GROUP Engine	MODEL 2011-2012MY Sportage (SL) Turbo
	NUMBER 130 (Rev 1, 01/17/2014)	DATE July 2013
TECHNICAL SERVICE BULLETIN		
SUBJECT: ECM UPGRADE – REFLASH AND EWGA ADJUSTMENT PROCEDURE (SA 149)

**SUBJECT: ECM UPGRADE – REFLASH AND EWGA ADJUSTMENT
PROCEDURE (SA 149)**

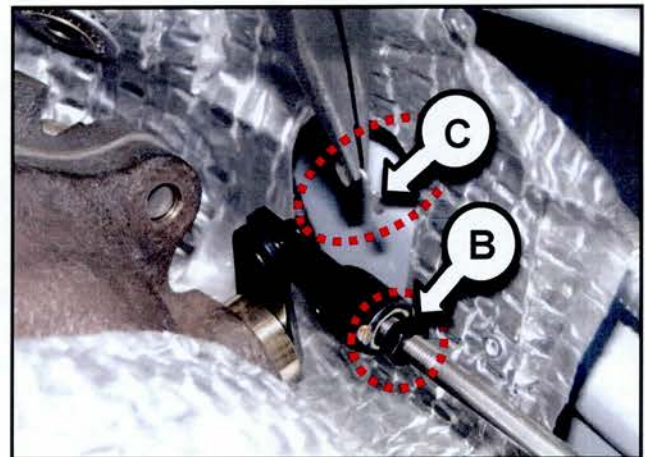
2. Remove the turbocharger upper heat shield bolt (A) to allow for access to the EWGA rod attachment point.

3. Loosen the rod end lock nut (B) and remove the retaining clip (C).

- Adjust the rod end by rotating it clockwise or counterclockwise until specification is within range (See Tables A and B below). Then, temporarily install the rod end and tighten the rod end lock nut. Check the **Adaptation Value for the Lower Mechanical Stop of Boost Pressure**, using GDS.

If unable to achieve proper voltage, it may be necessary to rotate the EWGA rod (D) to achieve proper voltage.

Specification: 4.1V (Cold Engine)

Coolant Temperature	Target Voltage
105.8 ~ 140 °F (41 ~ 60 °C)	3.80 ~ 4.00V
78.8 ~ 104 °F (26 ~ 40 °C)	3.85 ~ 4.05V
< 77 °F (25 °C)	3.90 ~ 4.10V

Rotate Rod (CW)	Estimated Voltage Change
½ Turn	0.15 ~ 0.20 V
1 Turn	0.30 ~ 0.40 V
